VEX U Robotics Competition 2026-2027: Override

3160: Clarification on Linear Motion Components Allowed by <VUR15>

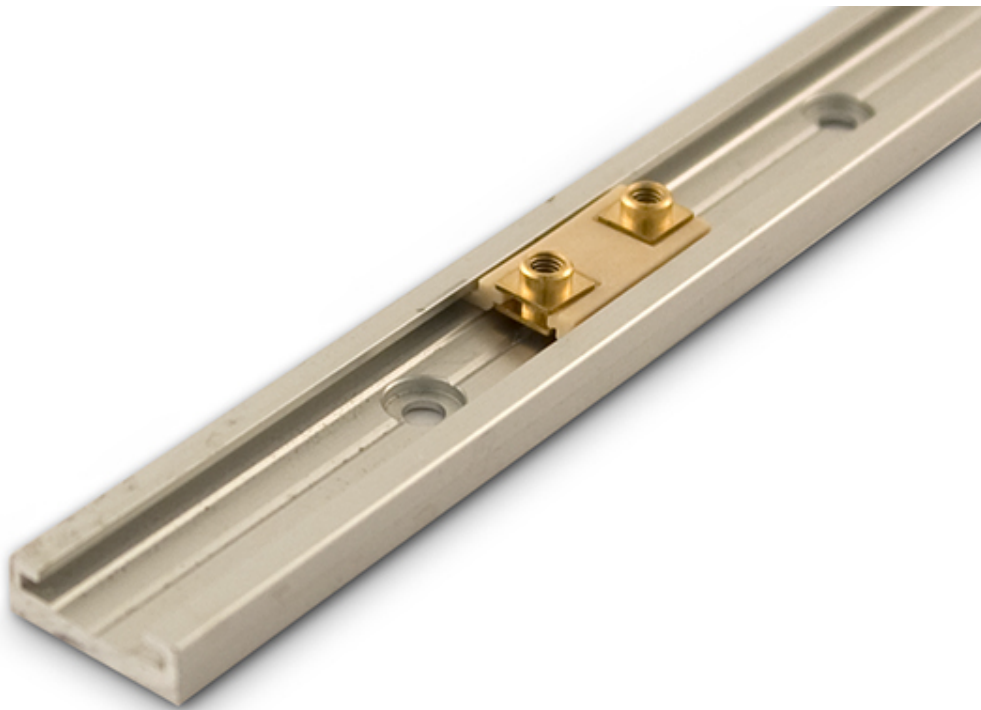
I would like clarification on the whether rail and carriage style linear motion components, such as the following examples, fall into this category of legal parts:

Specifically, the aspects of these rail and carriage components which are in question are:

1. Are there restrictions to the profile of the rails used? (round and rectangular are unambiguously legal as raw stock, but what about more complex profiles as shown in the example images)

2. Are there restrictions to the usage of the rails? (is it only legal when rail and carriage systems are used exclusively to provide linear motion functionality, or can they additionally provide some level of structure?)

Functionally, these components are quite similar to drawer slides, which both come in many complex profiles, and do provide some level of structure, although they could be categorized separately if there is a distinction to be made between linear "slides", versus linear "rails".

Both of the included pictures are of parts intended to support Linear Motion, and are considered legal for use in VEXU Robotics Competitions. There are currently no additional restrictions to the profiles of the rails.

Linear Rails, Bearings, Drawer Slides, etc. may provide structure or rigidity to a design, but it should remain clear that their usage is still to support the use of linear motion.
